**Attachment 1 - PLN17/0448-03 - 484 - 486 Swan Street Richmond - subject land  
- idac attachments**

**Attachment 2 - PLN17/0448-03 - 484 - 486 Swan Street Richmond - referrals final - idac attachment**

**Referrals**

Proposed Ground Floor Plan 1 : 200

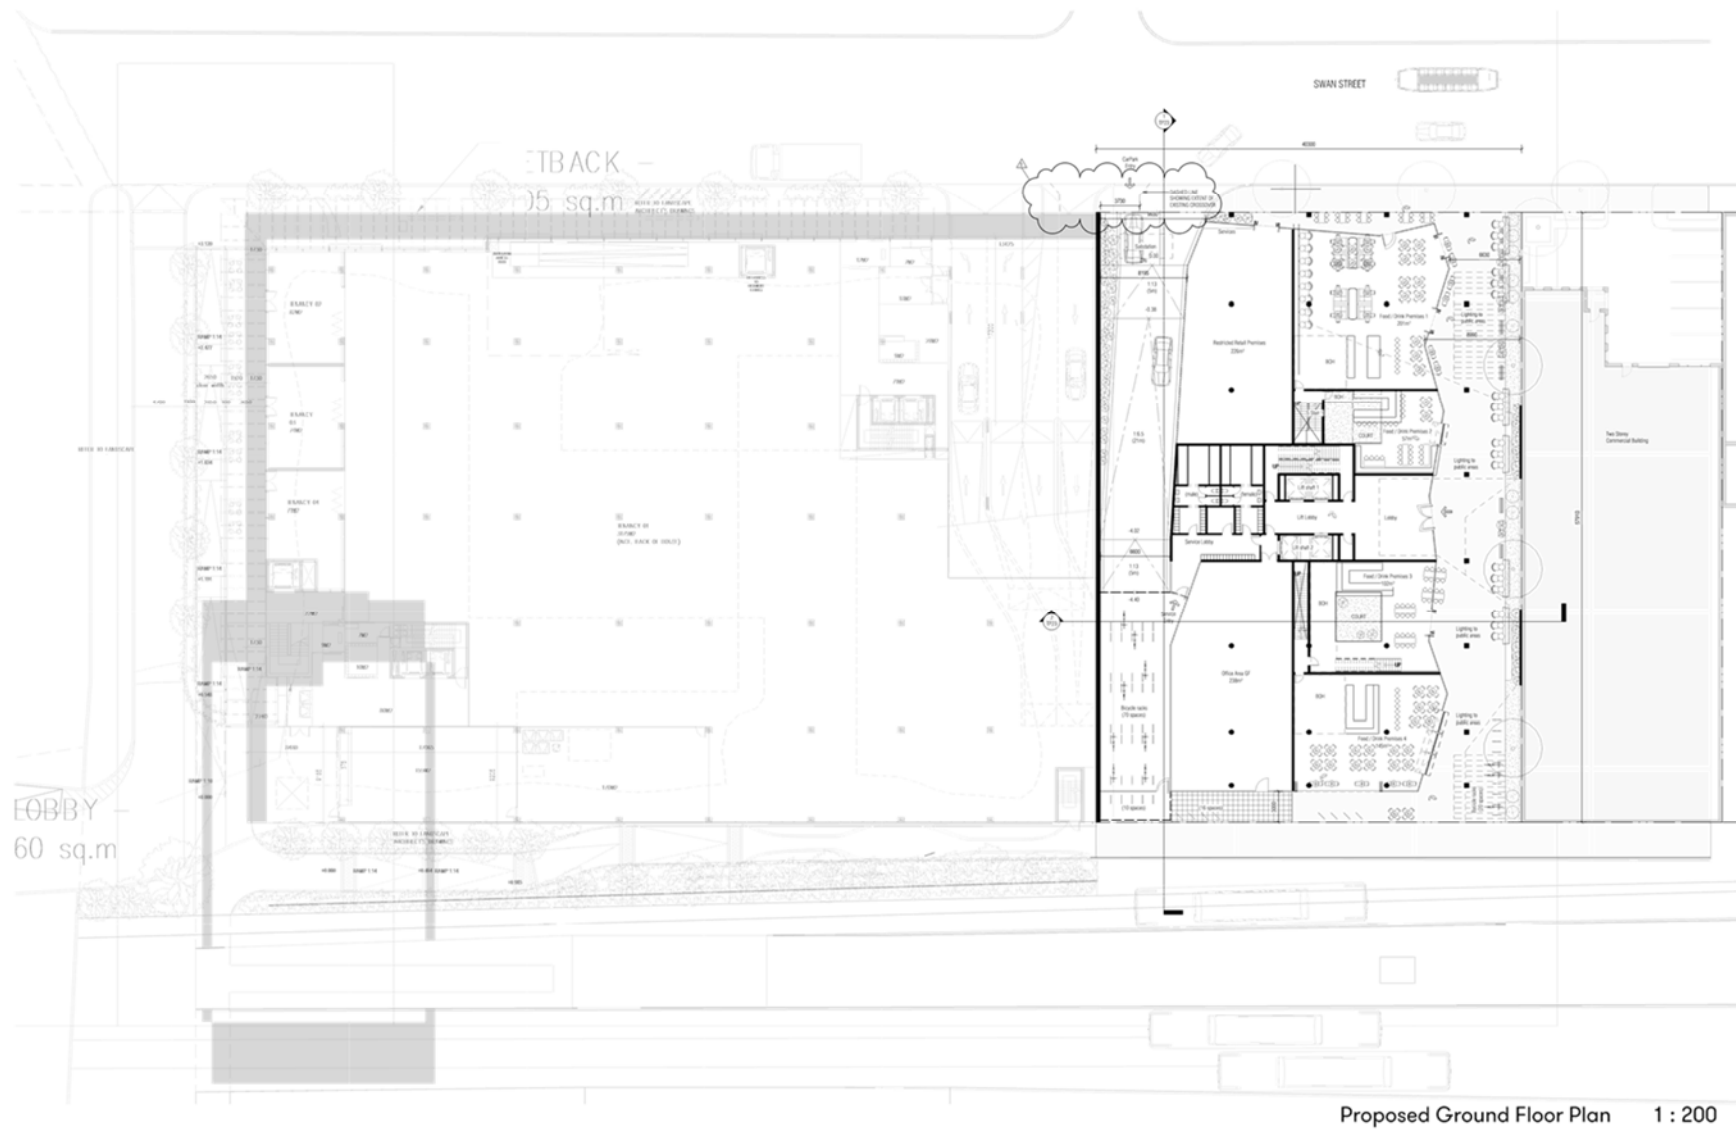
- *reduce the width of the crossover if possible*
- *provide pedestrian shelter to the Swan St footpath, avoiding conflict with street trees.*

The wide 9.915m crossover and large kerb radius are disruptive to pedestrian movement along Swan St. This is discussed below, under Street Interface.
